IDAP REPORT

Property:	91 Juno Parade GREENACRE Lot 1 in DP 35501 DA2021/126
Proposal:	Demolition of existing structures and construction of a two (2) storey dual occupancy with associated landscaping works.
Applicant:	Assurance Development and Construction Pty Ltd
Owner:	S M Sharker
Date of lodgement:	8 June 2021
Notification period:	15 to 29 June 2021
Submissions received:	Nil
Assessment officer:	M Rivera
Estimated cost of works:	\$750,000.00
Zoning:	R2 – Low Density Residential – SLEP 2012
Heritage:	No
Flood affected:	No
Is a Clause 4.6 Variation Proposed:	No
RECOMMENDATION OF OFFICER:	APPROVAL

Figure 3: Ground Floor Plan

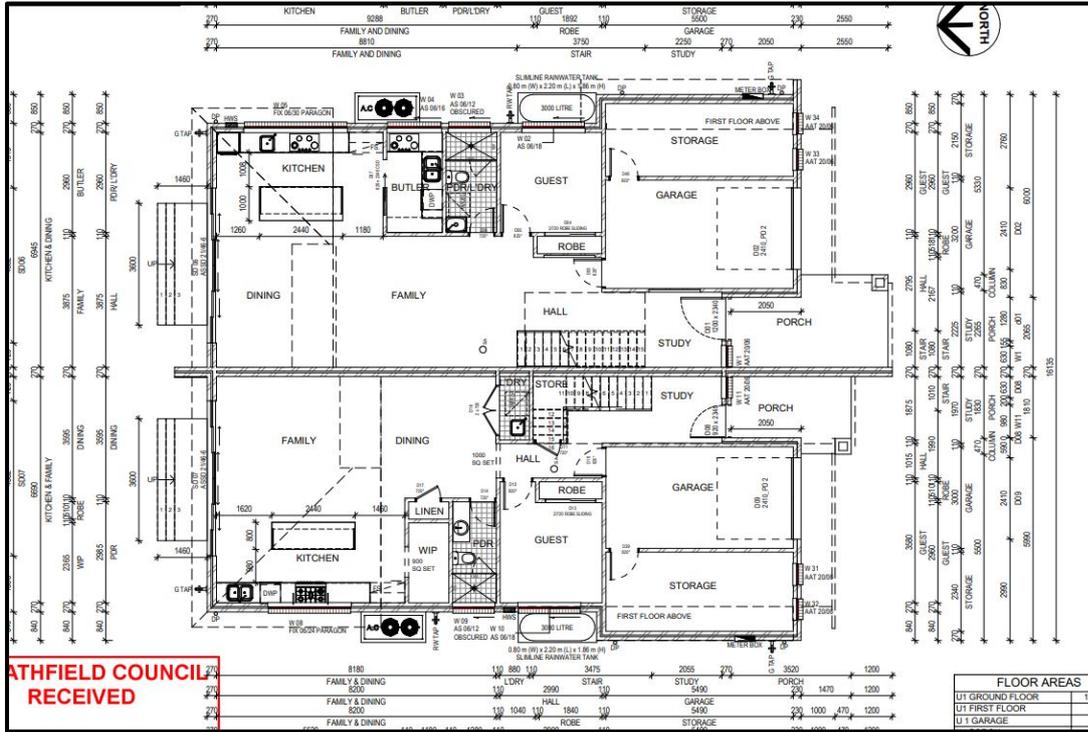
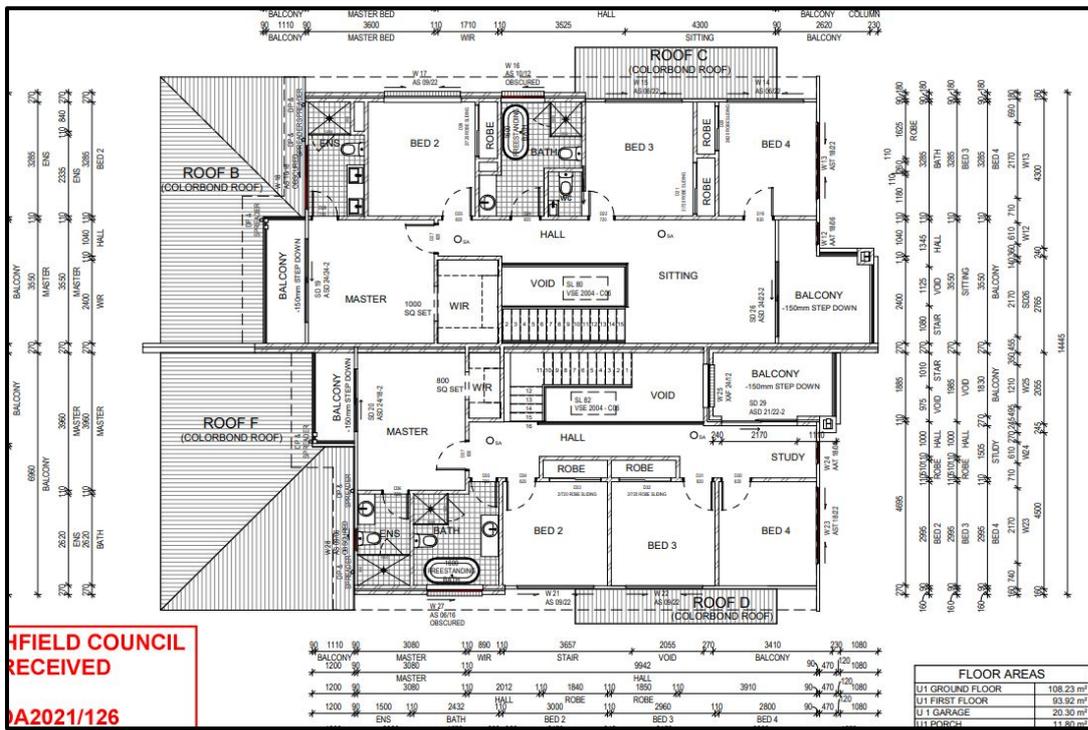
The front portion of the proposed dual occupancy development slightly extends beyond the building envelope as illustrated in Figures 3 and 4 under Section 2.2, Part B of the SCDCP 2005. This encroachment is considered to have merit given that it is only attributed to the modern, square shaped design of the development; which varies from the pitched roof form demonstrated in those figures. The overall massing and built form proposed are not considered excessive and have been appropriately balanced with a number of design treatments and landscaping. On balance, the variation to the building envelope requirement is reasonable and supportable.
